Subject: RE: La Crosse County Surveyor - For Review - CSM - Causeway Blvd 17-20251-15

The proposed Causeway Boulevard CSM has been reviewed. See comments below.

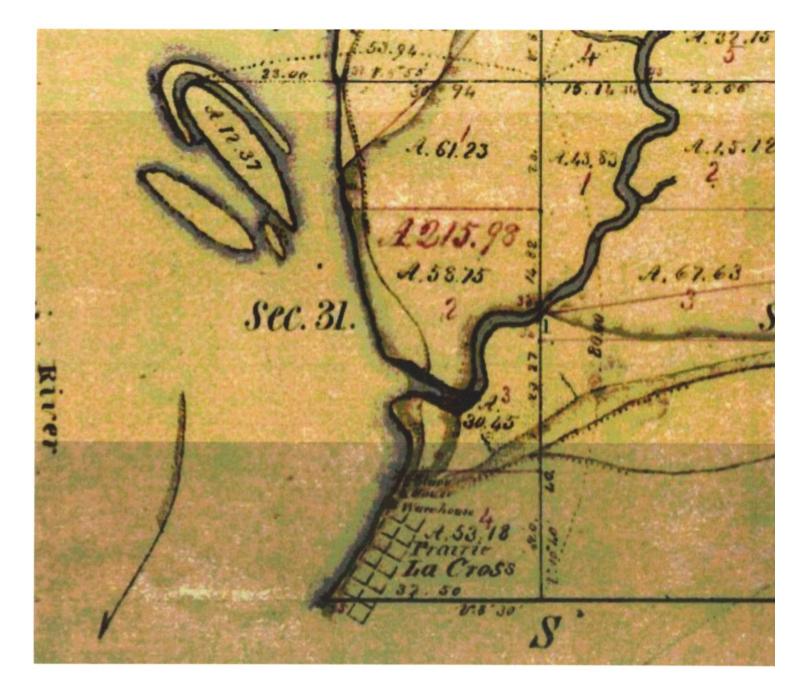
- 1. The caption on all four pages, along with the opening statement in the legal description states "located in the Northwest ¼ of the Northeast ¼". That statement is incorrect. There is no Northwest ¼ of the Northeast ¼ in Section 31. It is only Government Lot 1 as per the Original Government Plat Sheet (below). I realize that the plat of River Point District indicates that it is part of the Northwest ¼ of the Northeast ¼, but that is simply not true. Register of Deeds, Robin Kadrmas indicates that she only has tracting for Government Lot 1 in this area.
- 2. Please consider relabeling the north section line from the "NORTH LINE OF THE NE ¼ SECTION 31-16-7" to the "NORTH LINE OF GOVERNMENT LOT 1, SECTION 31-16-7.
